Re: DESKTOP REVIEW OF THE CSIRO PHASE 1, 2 AND 3A REPORTS FOR
ASSESSMENT OF THE ALCOA WAGERUP REFINERY EXPANSION

**REPORT FROM KATESTONE ENVIRONMENTAL
TO ALCOA WORLD ALUMINA AUSTRALIA**

**DESKTOP REVIEW OF THE CSIRO PHASE 1, 2 AND 3A FOR
ASSESSMENT OF THE ALCOA WAGERUP REFINERY
EXPANSION**

Figure 1: **Source identification using non-parametric regression for Boundary Road and Upper Dam NO$_x$ data**

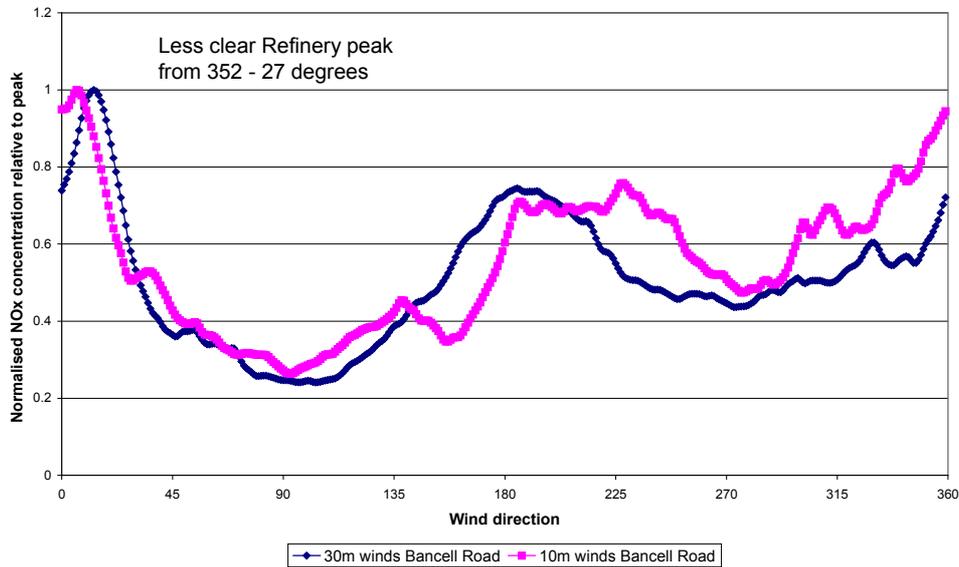
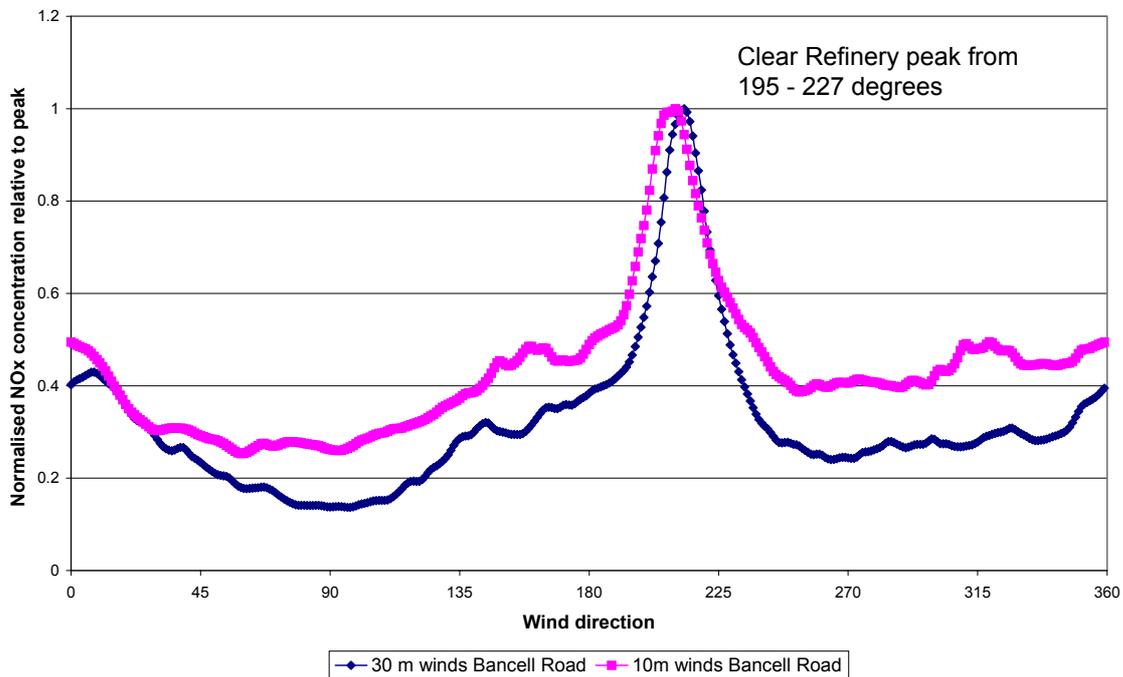
Figure 1 shows that there is a clear refinery signal in the Upper Dam site data but a variety of possible sources for the other site. Figure 2 suggests that there are many instances of concurrent events at both sites, suggesting a regional, rather than refinery source.

Figure 3: **NO$_2$/NO$_x$ ratio versus NO$_x$ concentrations for winds from refinery sector for (a) Boundary Road and (b) Upper Dam**

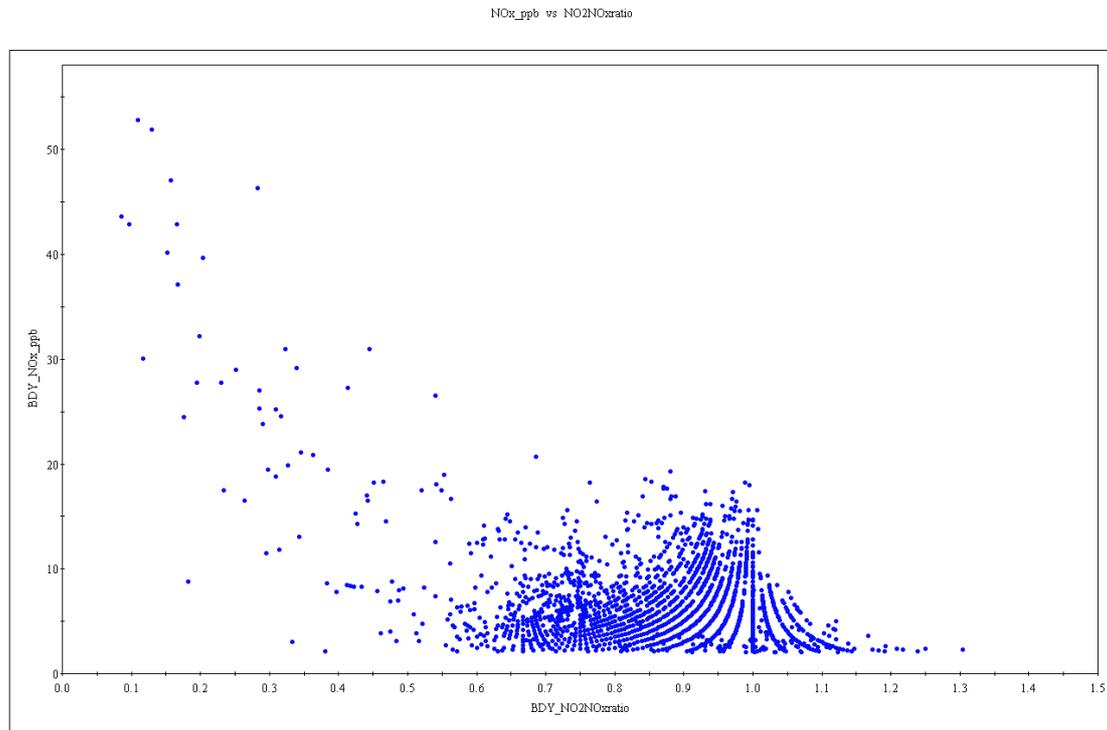
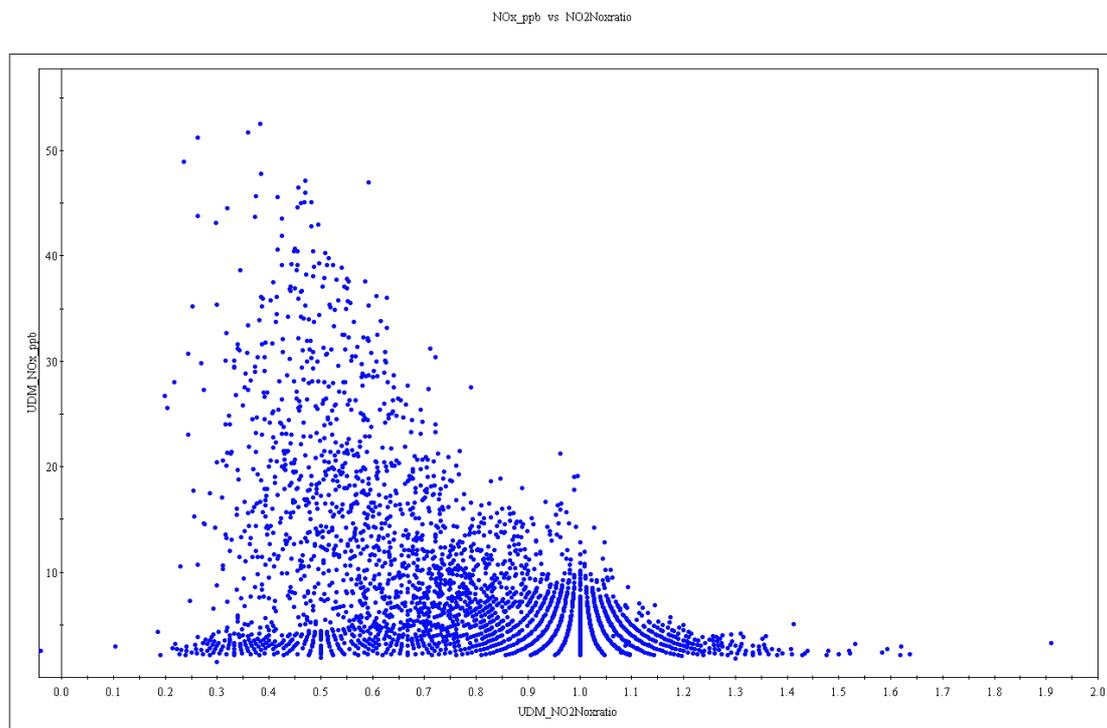
The ratios of nitrogen dixode to total nitrogen oxides for the refinery sources are expected to be around 0.1 at stack exit and 0.2 - 0.3 within the first 3 kilometres or so from the relevant sources. Figure 3 then shows that there is an obvious refinery source for the Upper Dam data but other sources are important for some of the moderate-size events.

Figure 4:   Comparison of wind roses for concurrent data recorded at (a) RDA and (b) Bancell Road 30m

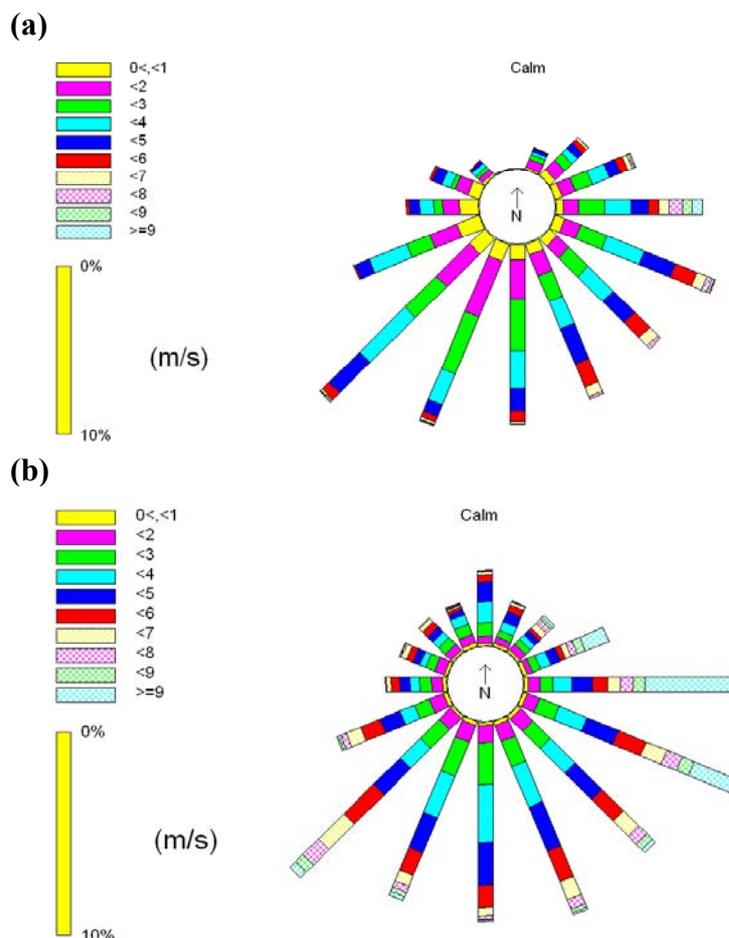
The CSIRO report also evaluates the performance against information from the RDA site to the west of the refinery. The meteorological monitoring data recorded at RDA site may be invalid or contains errors as there are few winds from the north-north west or northerly sectors. The figures below show the wind roses for RDA and 30 m winds at Bancell road site for the period of concurrent data (December 2003 to April 2004).

Figure 5:   **Analysis of Upper Dam for peak 6 minute verses 1 hour average NO_x data for winds from Refinery sector (195-227°)**

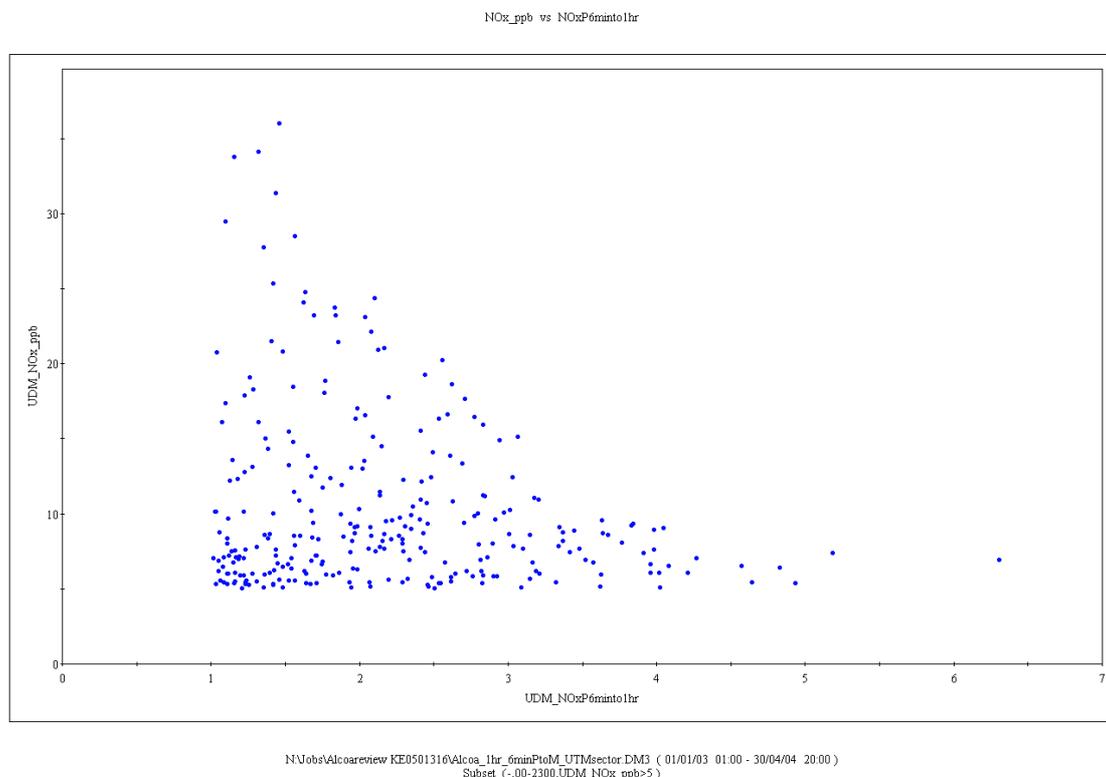
Figure 3 below presents a scatter plot of the measurements from Upper Dam site when winds were from the Refinery for hourly averages verses peak 6-minute concentrations recorded for each hour. It can be seen that for the highest hourly average concentrations recorded (>30 $\mu g/m^3$) at the Upper Dam site the peak 6-minute average is about 1-1.5. For lower concentrations the spread in the ratio is much greater with ratios up to 2.5 for concentrations of 20 $\mu g/m^3$. This shows that for differently hourly average concentrations the peak concentrations within the hour can be the same (e.g. 30 $\mu g/m^3$ x 1.5 or 18 $\mu g/m^3$ x 2.5 both equal a peak 6-minute concentration of 45 $\mu g/m^3$).

Figure 6:   **Cumulative frequency distribution of measurements of NO$_x$ at Upper Dam for winds from the Refinery for hourly and 6 minute averages and for estimated 6 minute averages using exponents of 0.12 and 0.23.**

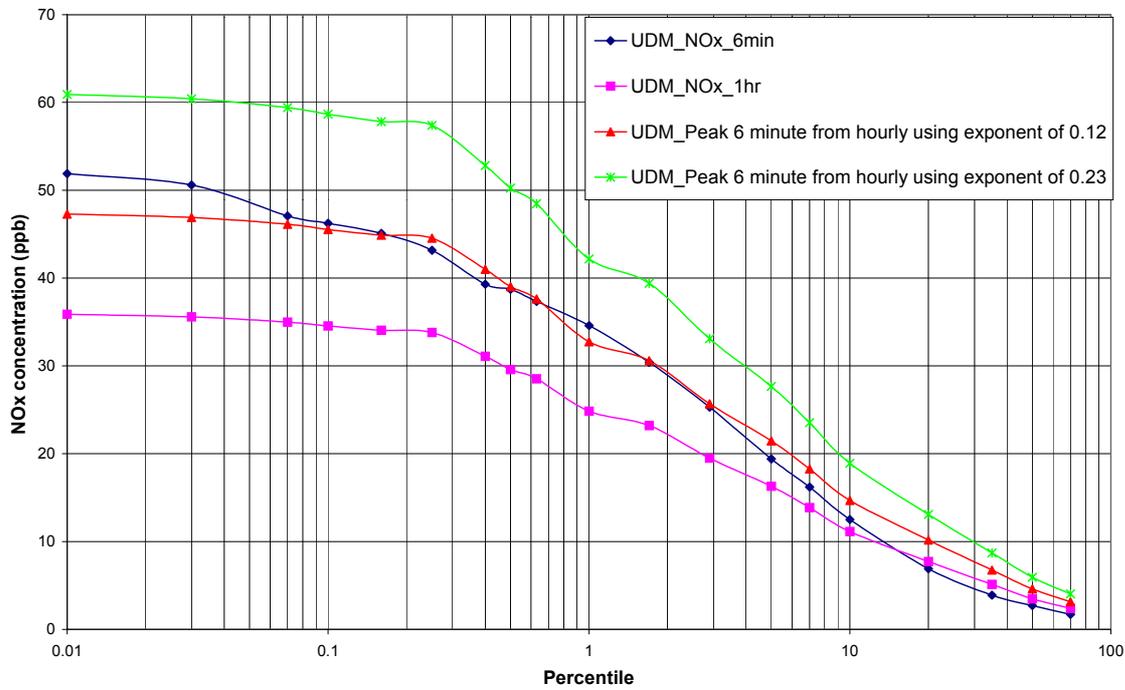
Figure 4 presents the frequency distribution of measurements from the Upper Dam site for the times winds were blowing from the Refinery. From the hourly average frequency distribution the peak 6-minute concentrations have been estimated using the method described in the CSIRO report with exponents in the range 0.12 to 0.23. The distribution of 6-minute concentrations indicates that the exponents used by CSIRO are within the range of the measurements (0.23 is actually slightly high).

The peak to mean ratios found from the measurements are much lower than expected based on experience elsewhere. It is not known if this relatively small power law exponent would translate for much shorter-term peaks, say 1 second, which are likely to drive the probability of complaints.

Figure 1: **Contour plot of predicted maximum 1-hour average concentrations of NO$_x$ for current operating scenario (6600tpd) of Wagerup Refinery predicted by TAPM with data assimilation.**

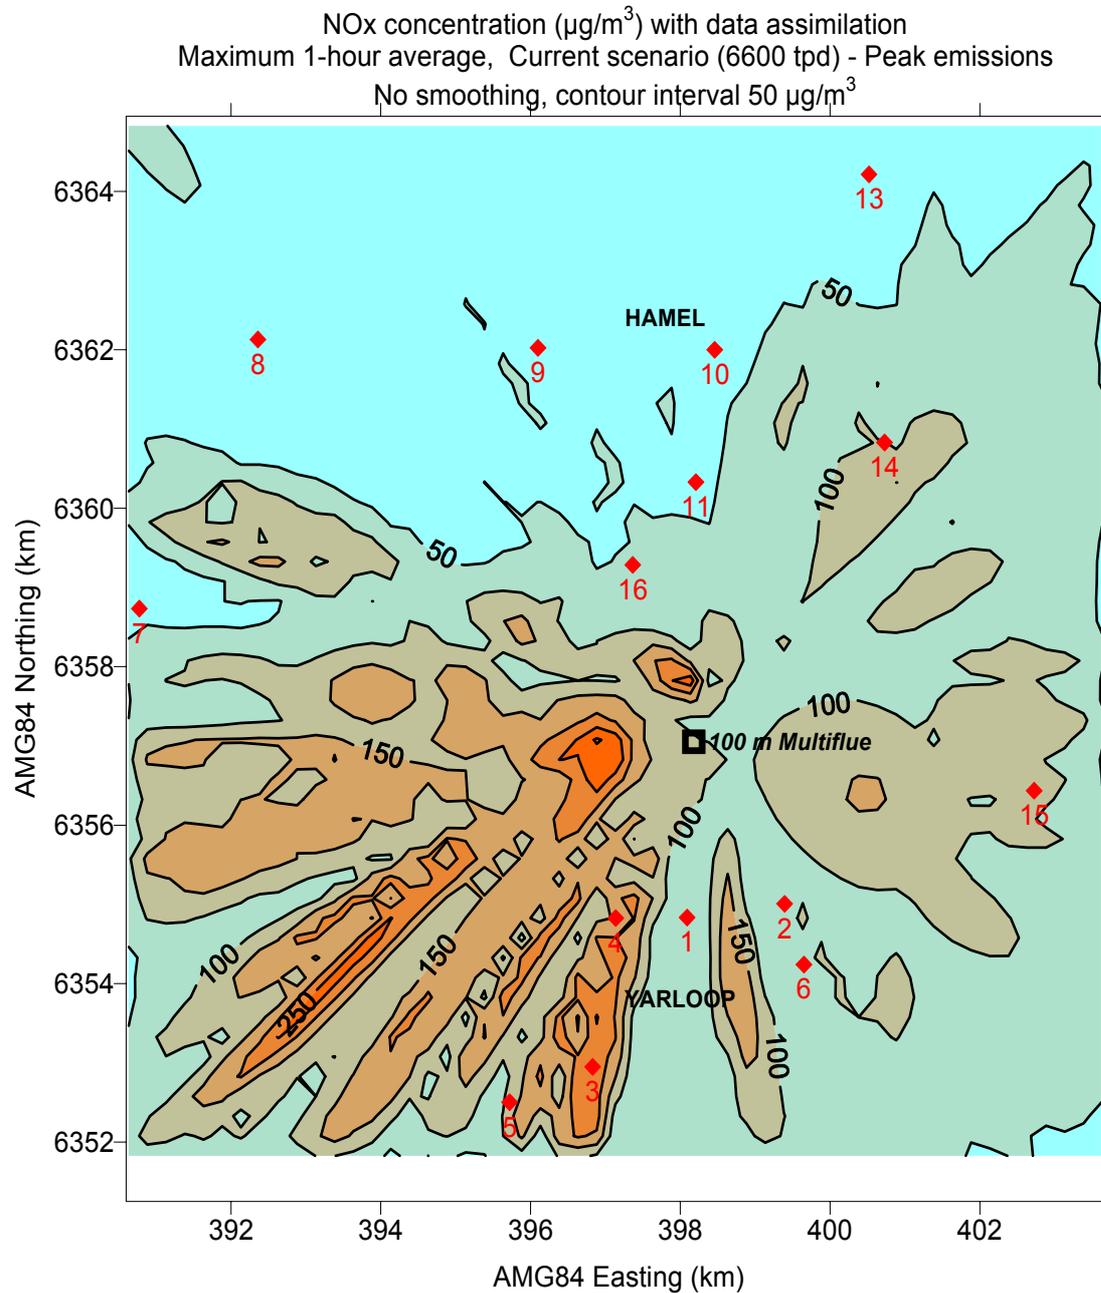
The figure indicates the plumes are very narrow and demonstrates the large variability in impacts for a particular location. Therefore to reduce model uncertainty it is advisable to present the maximum exposed location as well as the individual receptors.

Figure 2: **Contour plot of predicted annual average concentrations of NO_x for current operating scenario and peak emissions (6600tpd) of Wagerup Refinery predicted by TAPM (a) without and (b) with data assimilation.**

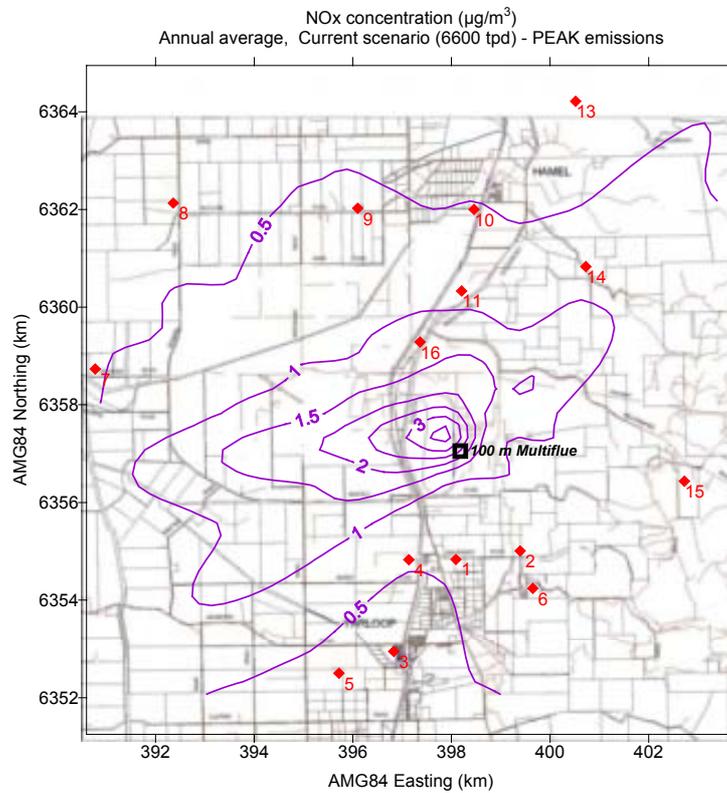
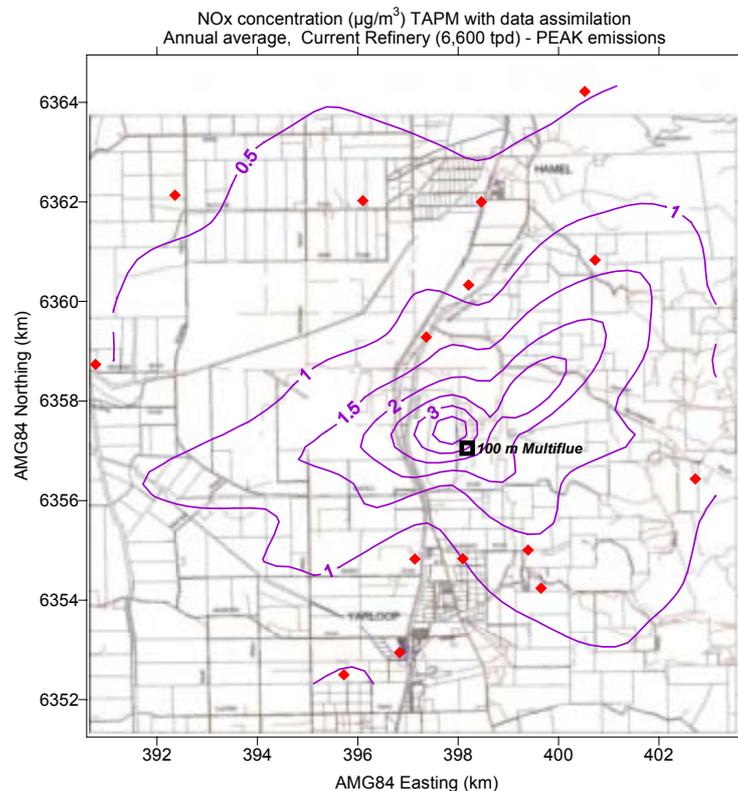
Figure 2 presents the contour plots for annual average concentrations with and without data assimilation. Predicted concentrations at all locations remain the same or increase by as much as 100% at a particular location. The maximum on the model domain is also increased by 100% with the inclusion of data assimilation, as are most locations in Yarloop. This is probably due to the assimilated data slowing down the TAPM winds and increasing the frequency of northerly winds and hence predicting higher concentrations particularly in Yarloop.
